## **Minutes of the meeting of the Planning Committee held at Banwell Youth & Community Centre, 7 pm on Monday 12<sup>th</sup> of May 2025.**

# PLANNING COMMITTEE REFORM – SUMMARY & KEY CONCERNS

# **25/P/0063/FUL Building at Chestnut Farm Wolvershill Road Banwell BS29 6LA**

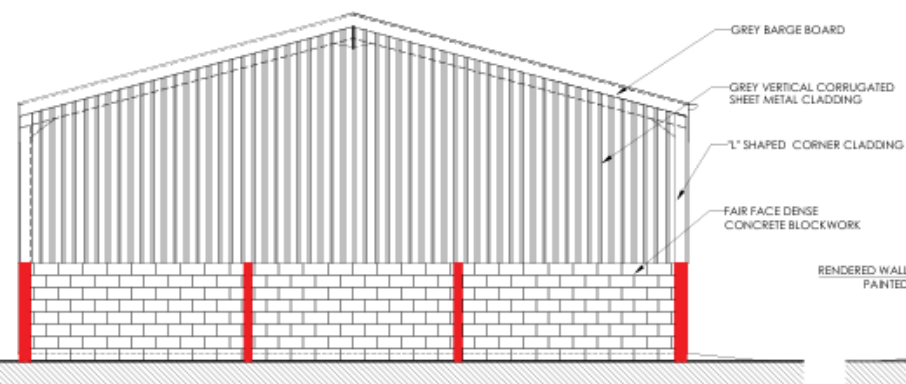
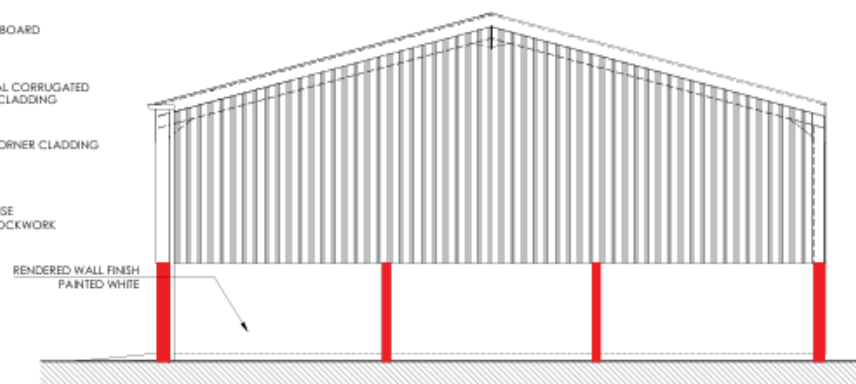
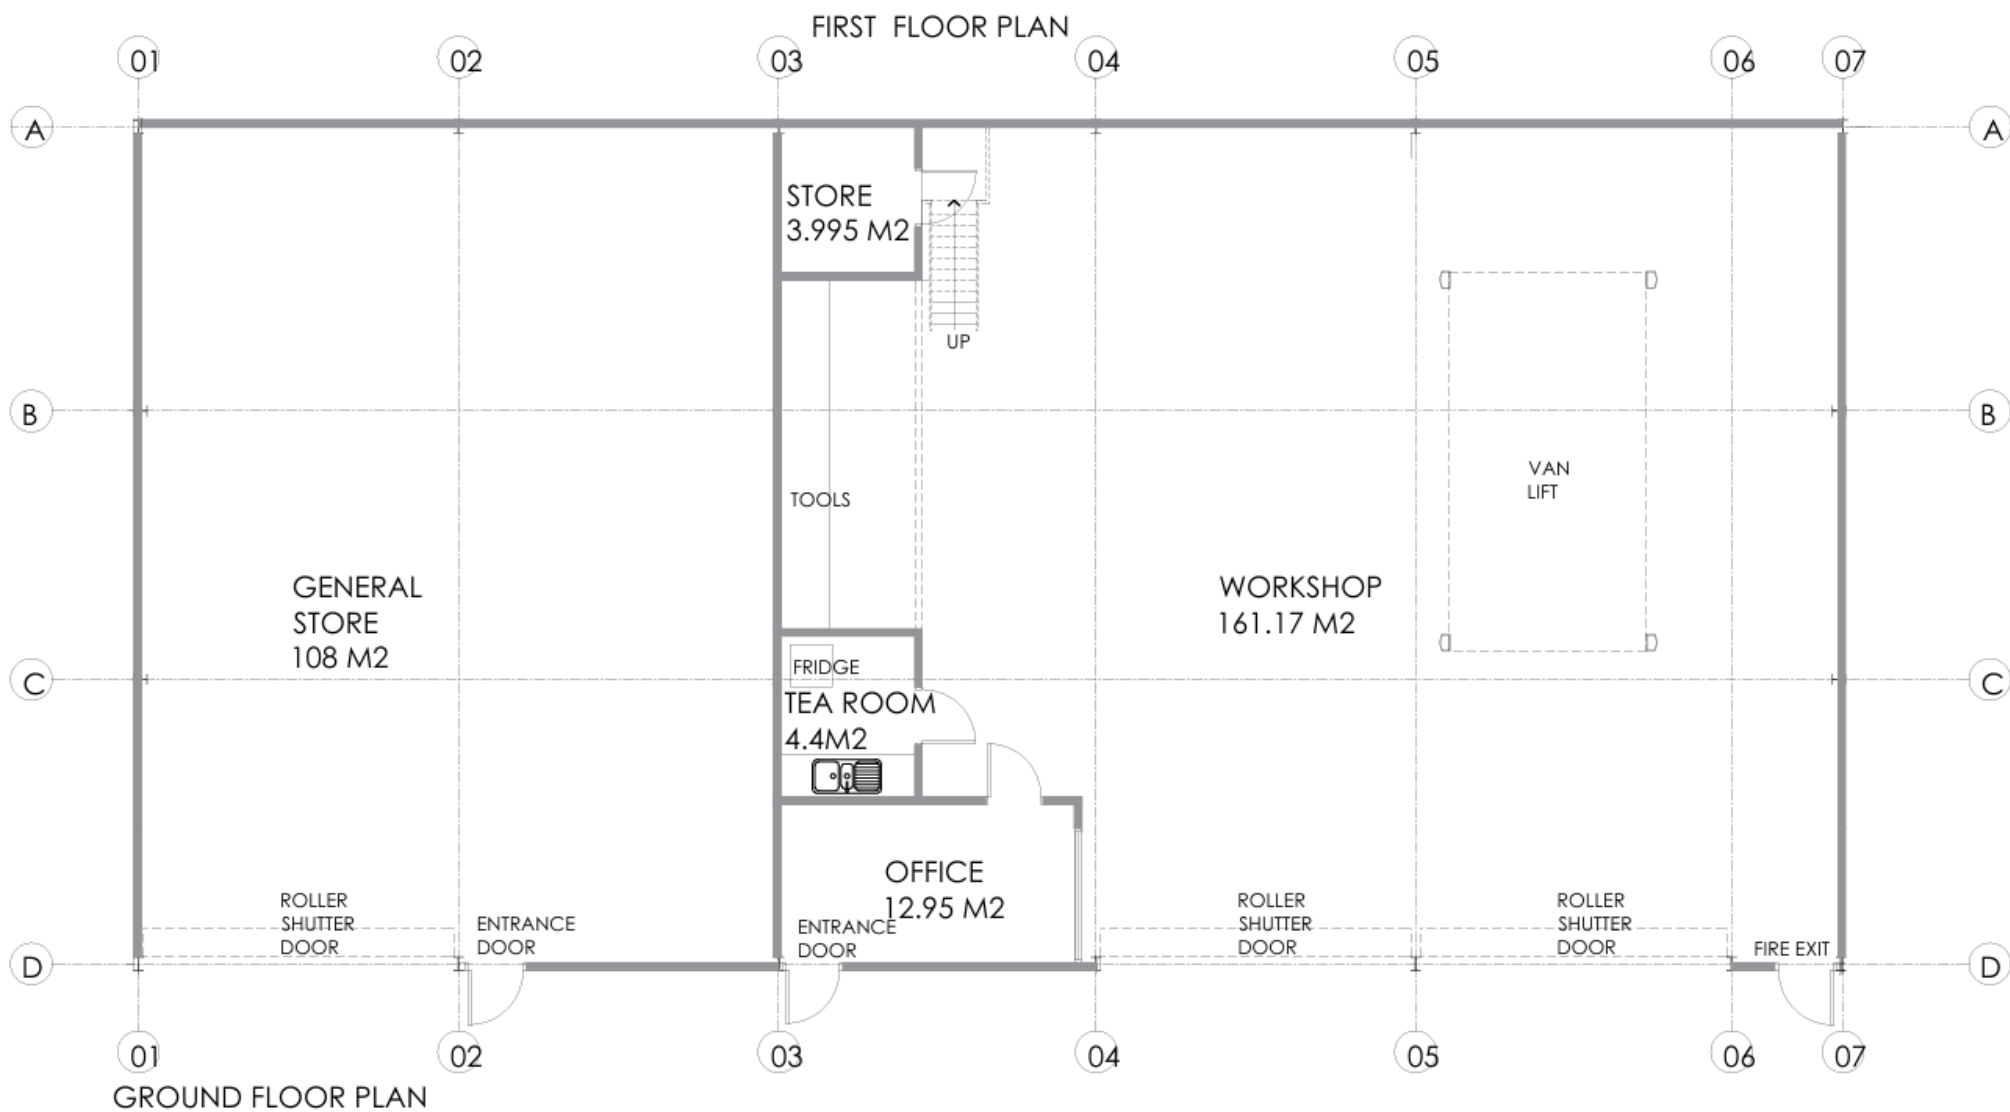
Topic	Environment and biodiversity comments	Recommendation
Lighting	This site lies within Zone C of the North Somerset and Mendip Bats Special Area of Conservation (SAC), where lighting can have a significant impact on bat activity. Light pollution is a particular concern given the site's proximity to two wildlife corridors to the east and south, which are due to be enhanced through the Wolvershill development.	A condition should require a retrospective lighting assessment to ensure any external lighting installed is essential use only ( limited to operational hours, 08:00–17:30), downward-facing, and uses low-lumen, warm-spectrum bulbs.
Surface Runoff and Oil Contamination	The change of use to a car workshop increases the risk of oil and chemical pollution entering local watercourses via surface runoff. To prevent environmental harm, the site must have impermeable surfaces, a sealed drainage system, and a properly maintained oil interceptor none of which are detailed in these plans.	A condition should be imposed requiring the applicant to provide details of impermeable surfacing, a sealed drainage system, and a properly maintained oil interceptor, to prevent oil and chemical pollution from entering local watercourses via surface runoff.

# **25/P/1057/FUH & 25/P/1058/LBC 60B**

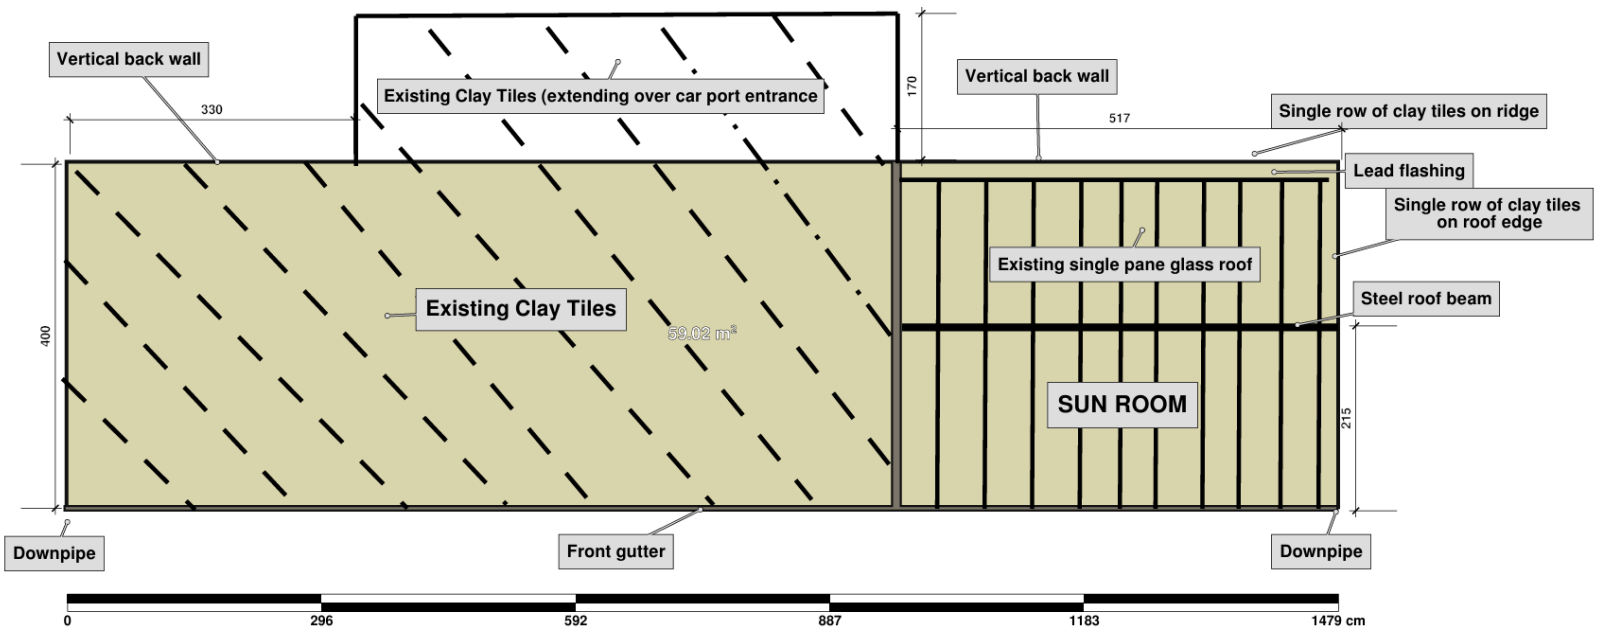
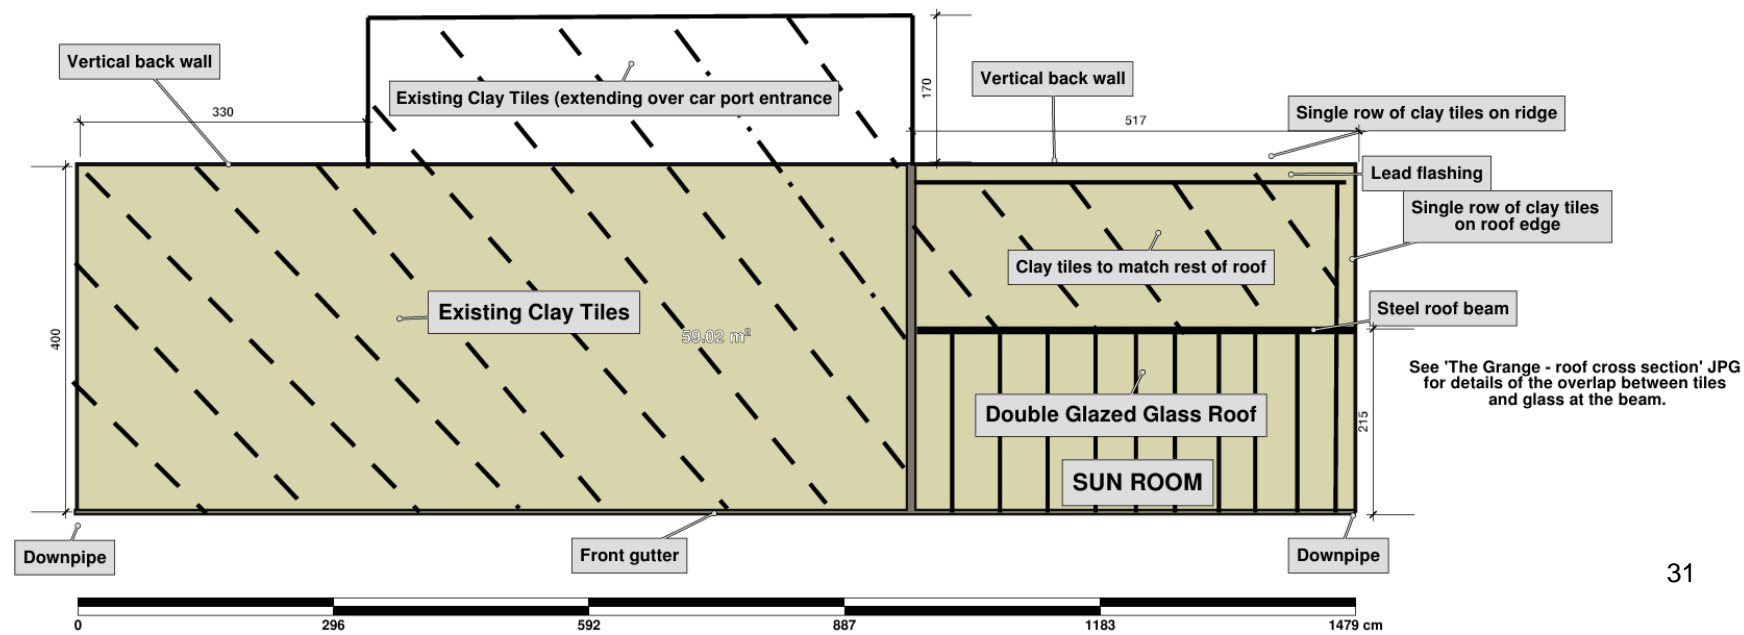
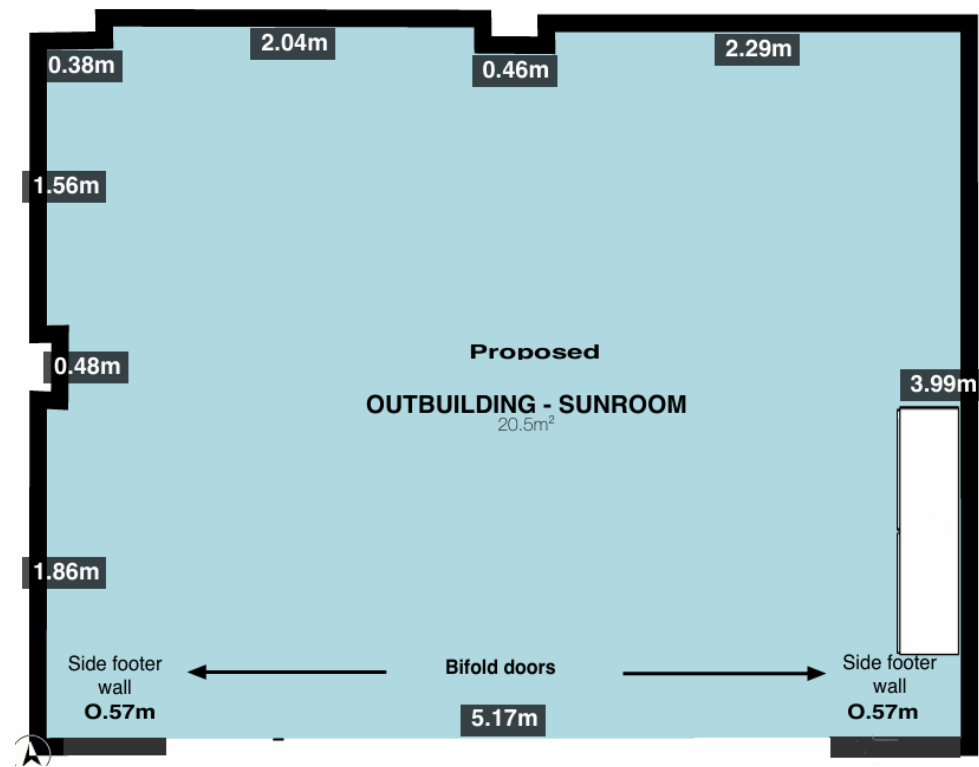
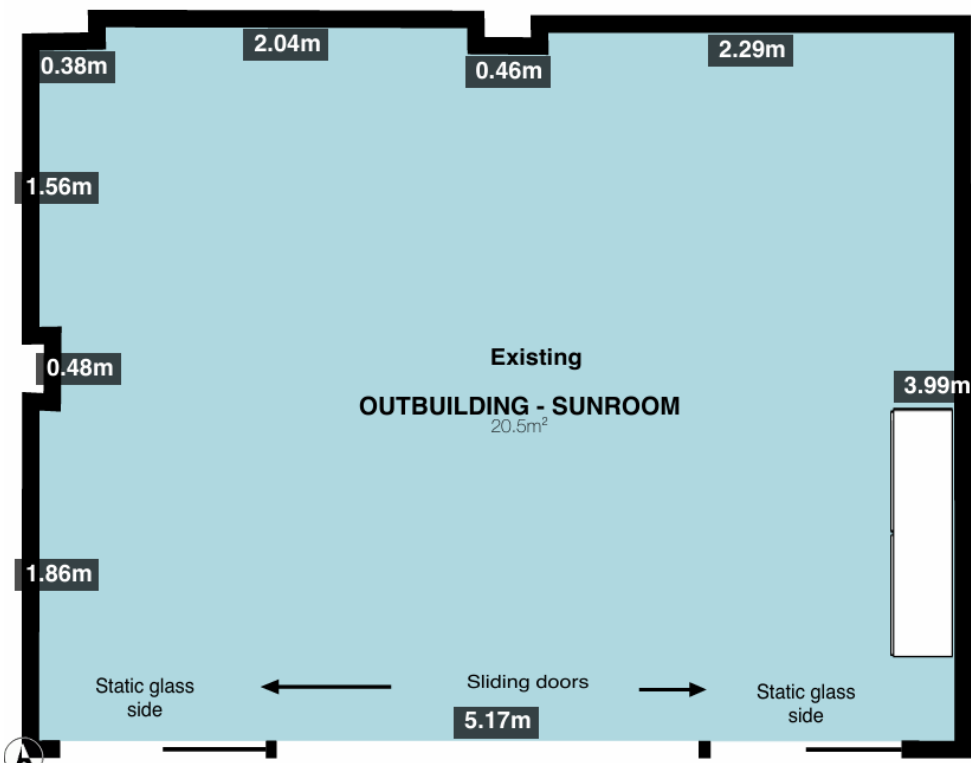
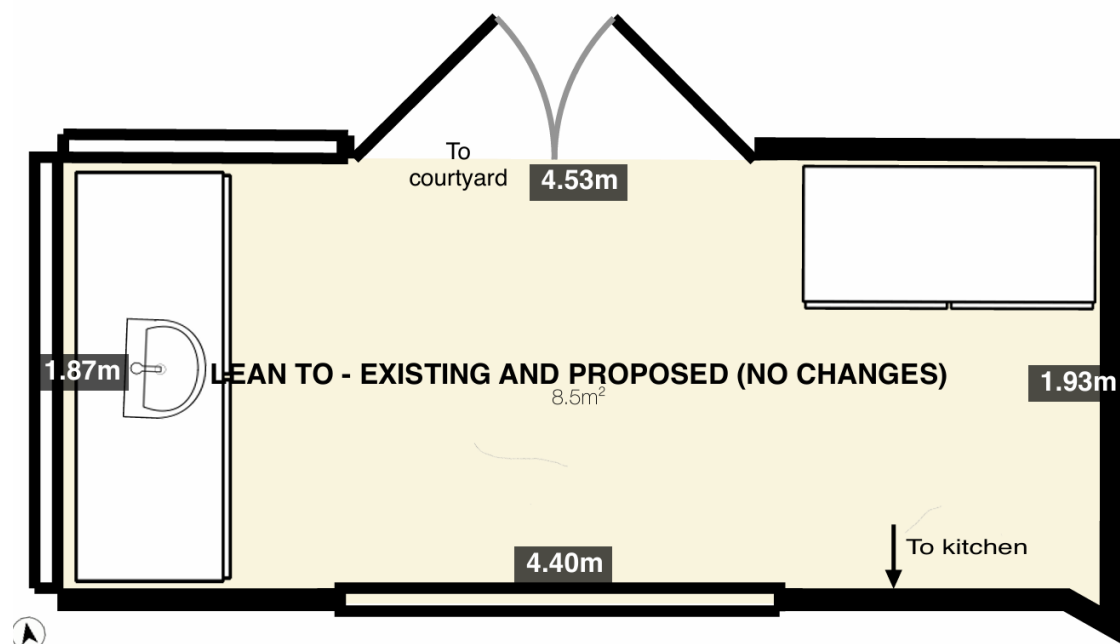
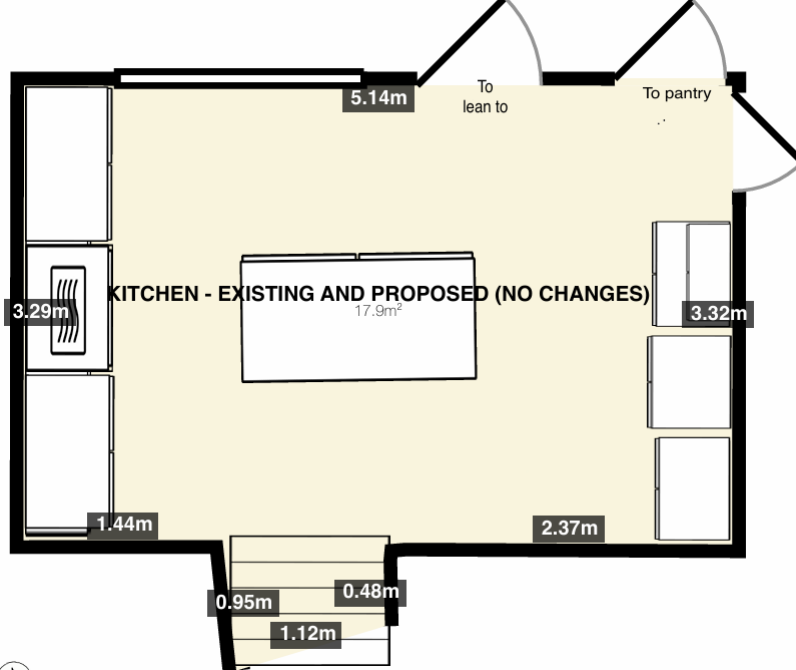
Topic	Environment and biodiversity comments	Recommendation
Sustainable drainage	The proposed repairs and upgrades present an excellent opportunity to incorporate rainwater harvesting systems to reduce surface runoff, lower demand on mains water, and promote sustainable management of surface water.	Encourage the application to explore opportunities to install water butts on both the rear lean-to extension and the sunroom (if not already in place).
July planning
